Implementor's Guide for Recommendation G.168

This document contains technical corrections and clarification for the implementation of Test No. 2C, Test No 3C, Test No. 5, Test No 7, Test No. 8, Test No 10A, Test No 14 and Figures 7, 9, 15 and 22 in Recommendation G.168 (04/00).

Figure 22: Performance requirements for test 7

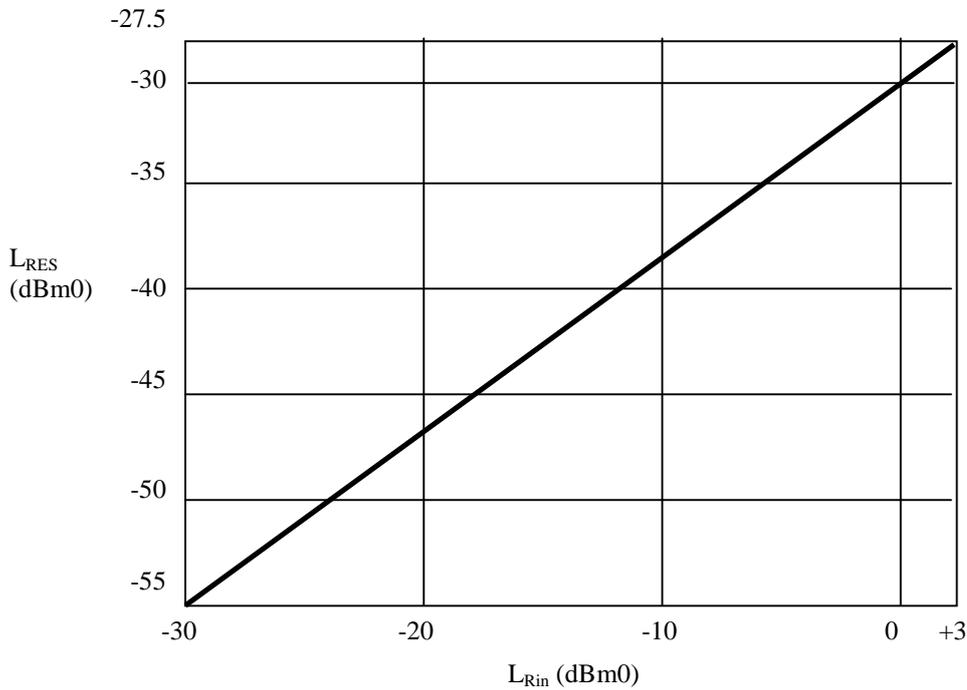
Note that the requirements for Test No. 7 are given in Figure 22. This graph gives L_{RES} plotted against L_{Rin} . The graph is intended to be a straight line between the following two co-ordinates:

(-30, -55)

(+3, -27.5)

The graph in Figure 22 is correct at these two points, but due to unequal spacing, is incorrect everywhere else. Figure 22 should therefore be deleted and replaced with the following:

Note that the equation for the line in Figure 22 is: $L_{RES} = 0.83L_{RIN} - 30$

Figure 7: Echo Path Model using $g(k)$

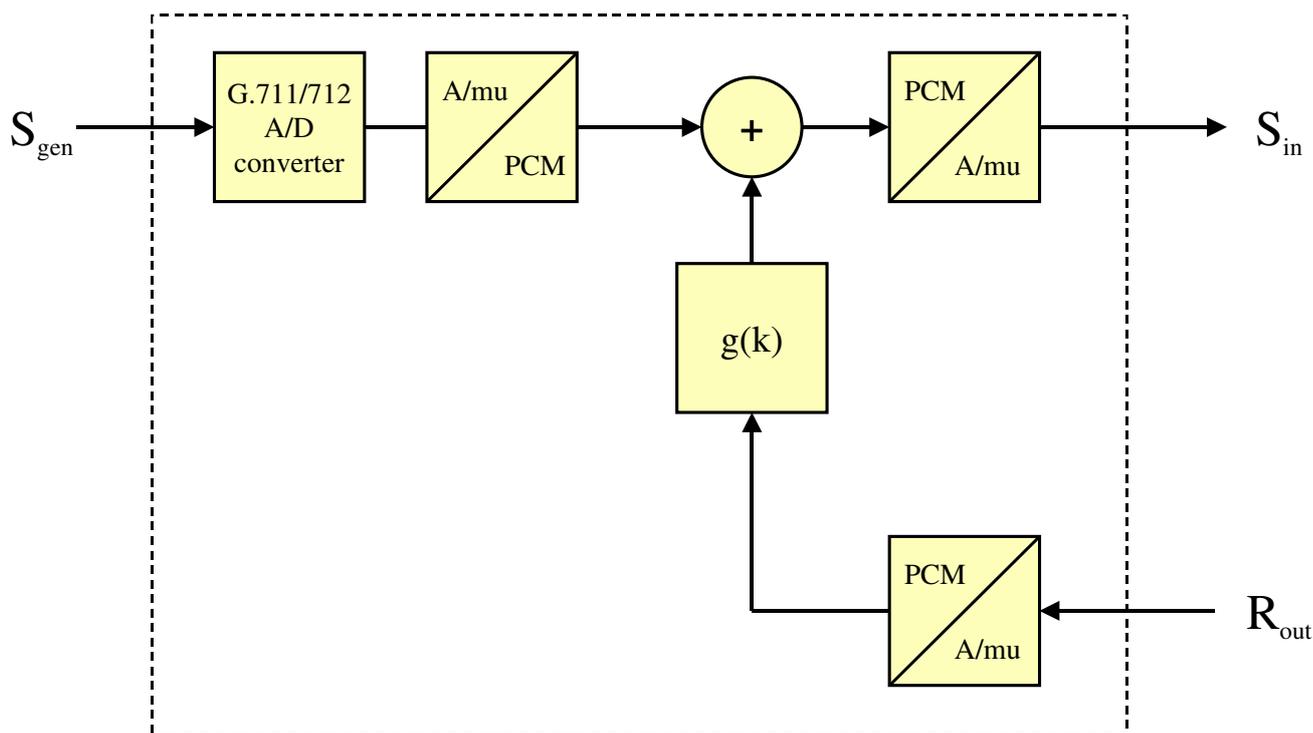
Figure 7 shows an echo path model using $g(k)$. This figure is incorrect, since it does not include any linear (PCM) to A/mu-law conversion. The following changes should be made to the paragraph immediately before Figure 7:

An echo path model which allows more realistic end-paths to be modeled can be realized by replacing the dotted box in Figure 6 with Figure 7. The characteristics of the end-path, which includes the A/mu-law converters, can be modeled as an impulse response $g(k)$.

In addition, Figure 7 should be deleted and replaced with the following:

Figure 15: Test No 2C Steady state requirements NLP disabled

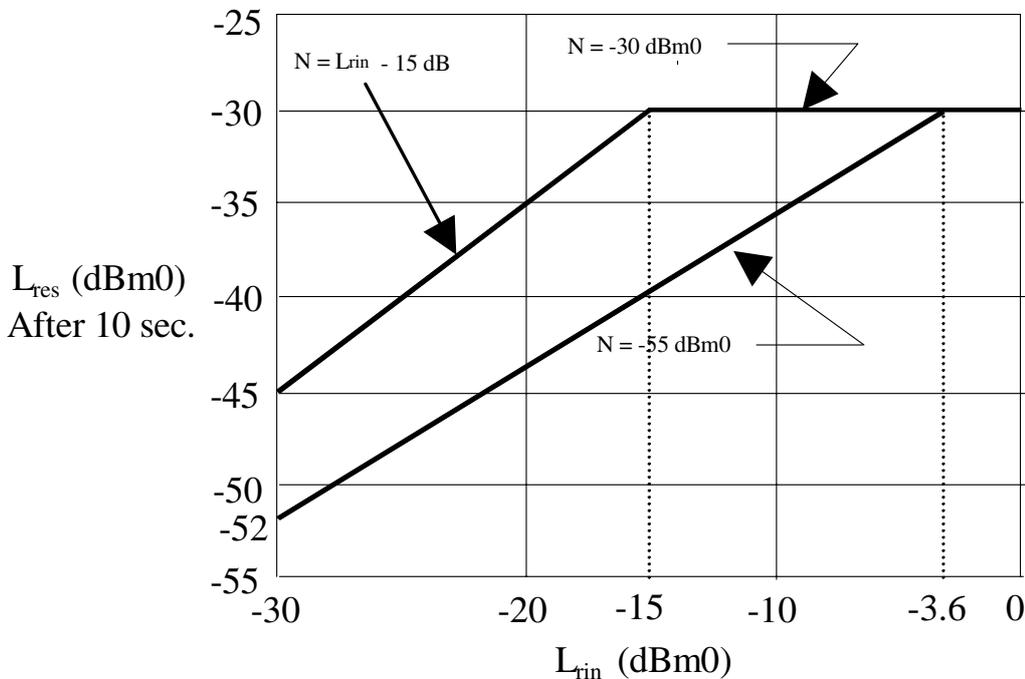
In addition, there has been some confusion over the requirements of Test 2C part (b) as given in Figure 15. This figure should therefore be deleted and replaced with the following:

Figure 9: Relationship between receive input level (L_{Rin}) and return echo level (L_{RET}) with NLP enabled

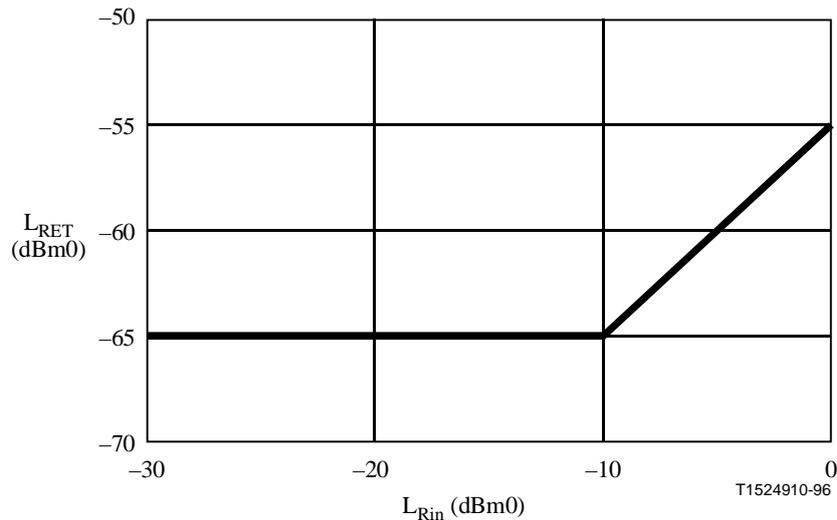
The requirements for this test are given in Figure 9, in which the horizontal portion of the curve does not show up in the printed document. Figure 9 should therefore be deleted and replaced with the following:
